ORIGINATION FORM

Proposed Revisions to a Standard Plans Index
(Please provide all information — Incomplete forms will be returned)

Index Number: 425-025
Sheet Number (s): ALL
Index Title: Curb Inlet Top Type 10

SHEET 2

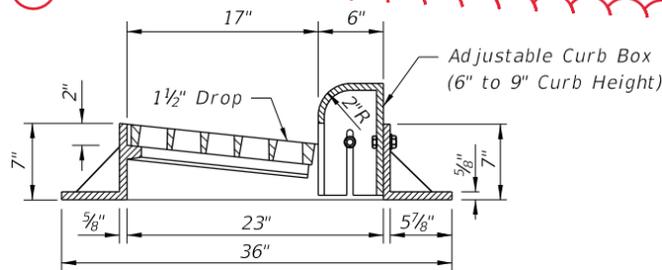
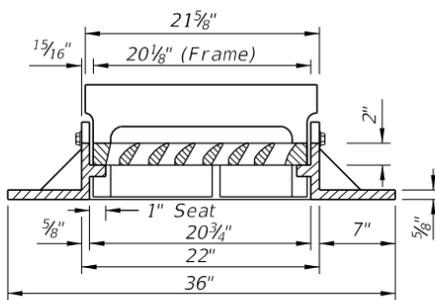
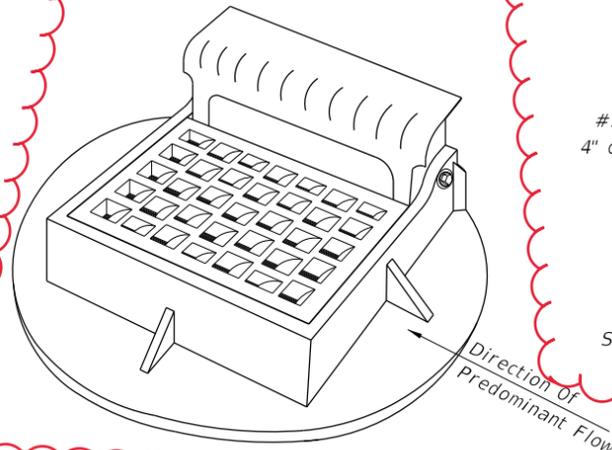
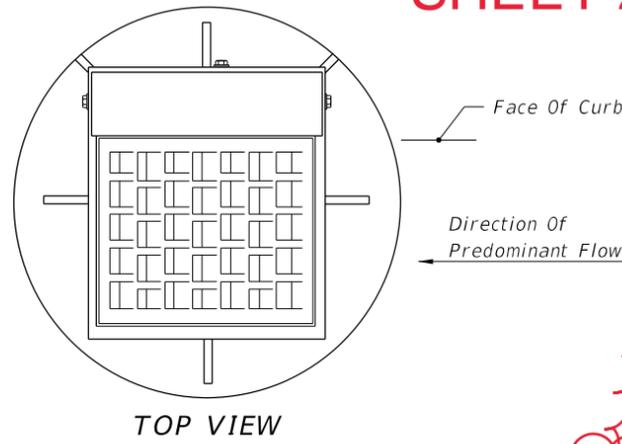
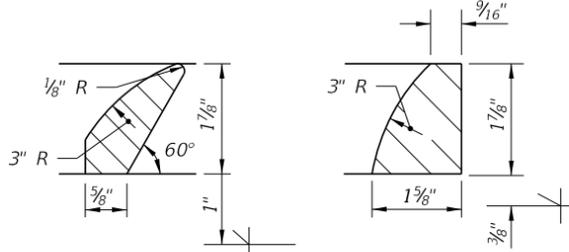
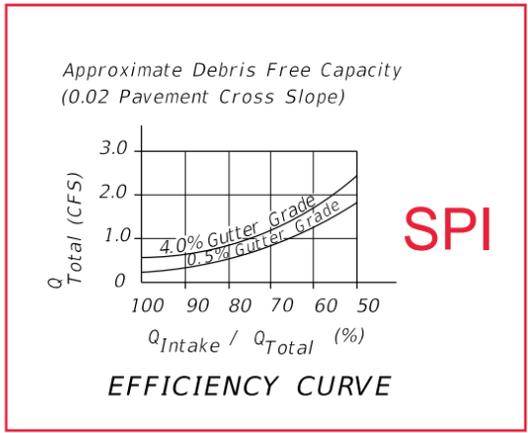
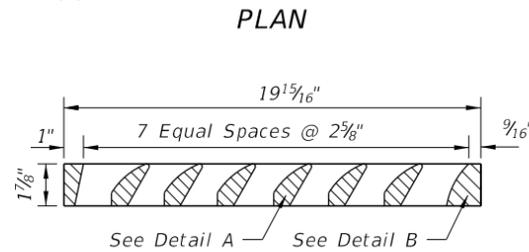
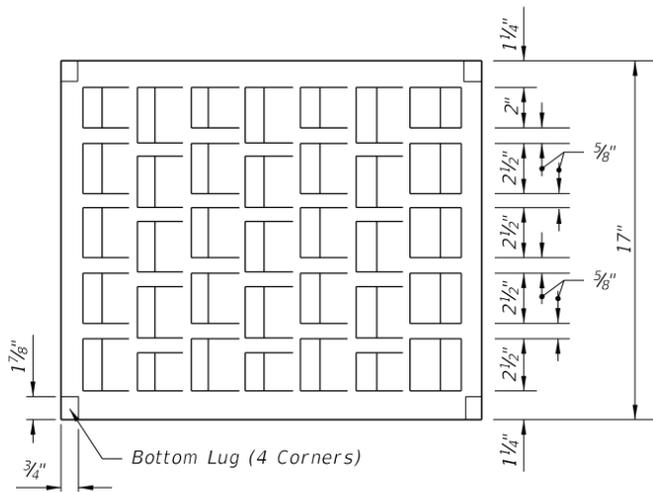
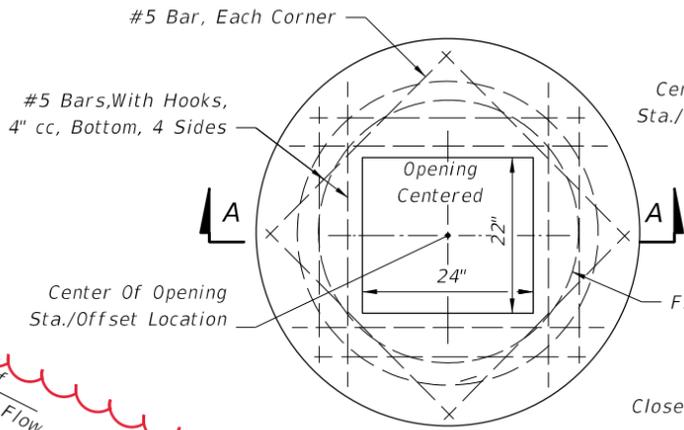
Reorganized Index, Added additional Sheets.
Sheet 1: General Notes
Sheet 2: Frame and Grate Details
Sheet 3: Top Slab Details

Reorganized Details and Sheets to declutter Index. Moved information from detail callouts to Notes in order to decrease clutter of the drawing. Moved design information to SPI.
